Mask Set Errata for Mask 0L31N

This mask set errata applies to the mask 0L31N for these products:

- MC68HC908EY16
- MC68HC908EY8

Figure 1. Maximum Time for Other Execution

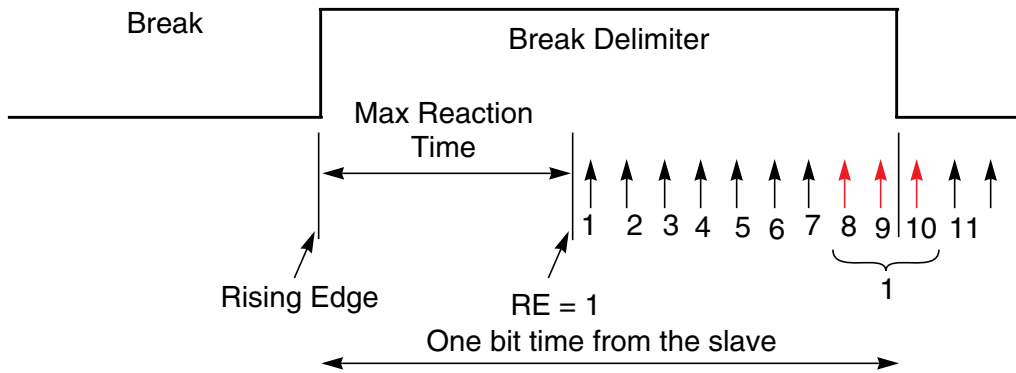
The time between when the rising edge actually appears on the receive pin and when the receiver is switched back on is finite and is governed by the timing of the falling edge of the delimiter. The receiver must be switched back on no later than 9/16th of a bit time before the end of the delimiter. See [Figure 1](#).

From [Figure 1](#), we also see that the “Maximum Reaction Time” is 7/16th slave bit-time.

The Maximum Reaction Time for this example system is $7/16 \times (44.5 \mu\text{s}) = 19.47 \mu\text{s}$.

From the instant the rising edge appears on the receive pin (detected via the arbiter AFIN bit or a timer interrupt), the software has to switch the receiver OFF and back ON within 19.47 μs .

Because ground shift in the physical layer might also affect the timing of the falling edge of the START bit of the 0x55 synch byte (i.e., the end of the delimiter), best design practices suggest that the switching of the receiver should be done as quickly as possible after the rising edge is detected. The maximum reaction time calculated above should be treated as a guideline only.
